NUMBER: 08-084-13 REV. A

Decklid Opens Unintentionally

2011 - 2013	LD	Charger
2011 - 2013	LX	300

Fig. 1 Passive Entry Switch Button Surface

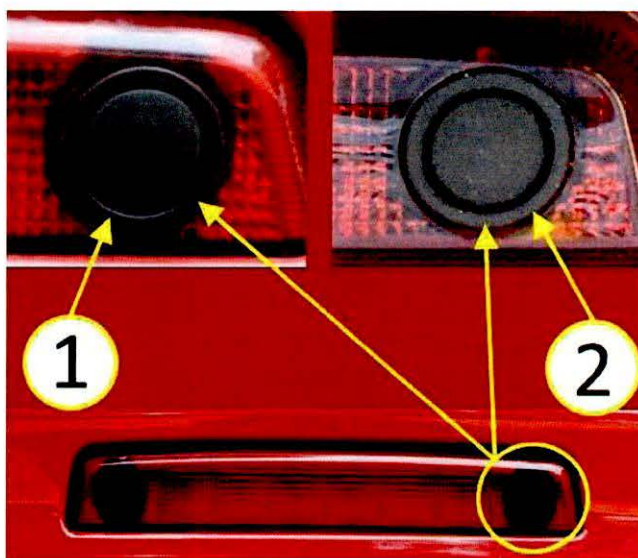
1. Determine if the trunk passive entry switch button surface is plastic (slippery) or rubber (grippy) by rubbing a finger across the switch button surface to detect the surface material. Appearance is very similar and may require careful examination to detect which version of switch is installed (Fig. 1).
 - a. Plastic (1) (Fig. 1) replace the switch, perform the repair procedure.
 - b. Rubber (2) (Fig. 1) no further action is required, return the vehicle to the customer.

Fig. 4 Switch Version

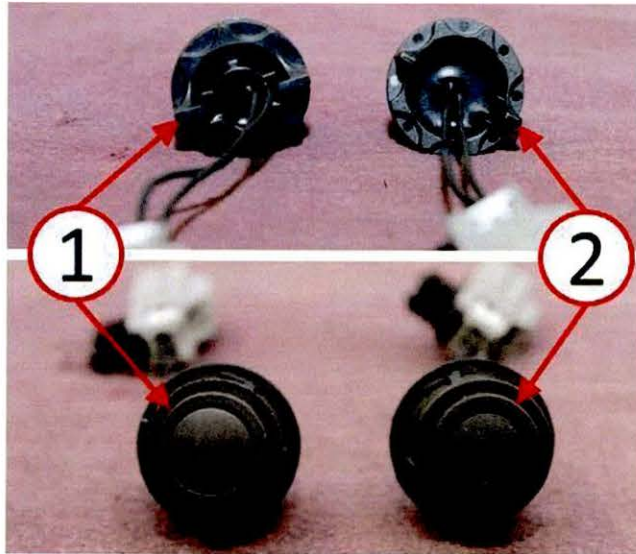
5. Replace previous version plastic button passive entry switch (1) with new version rubber button passive entry switch (2) (Fig. 4).
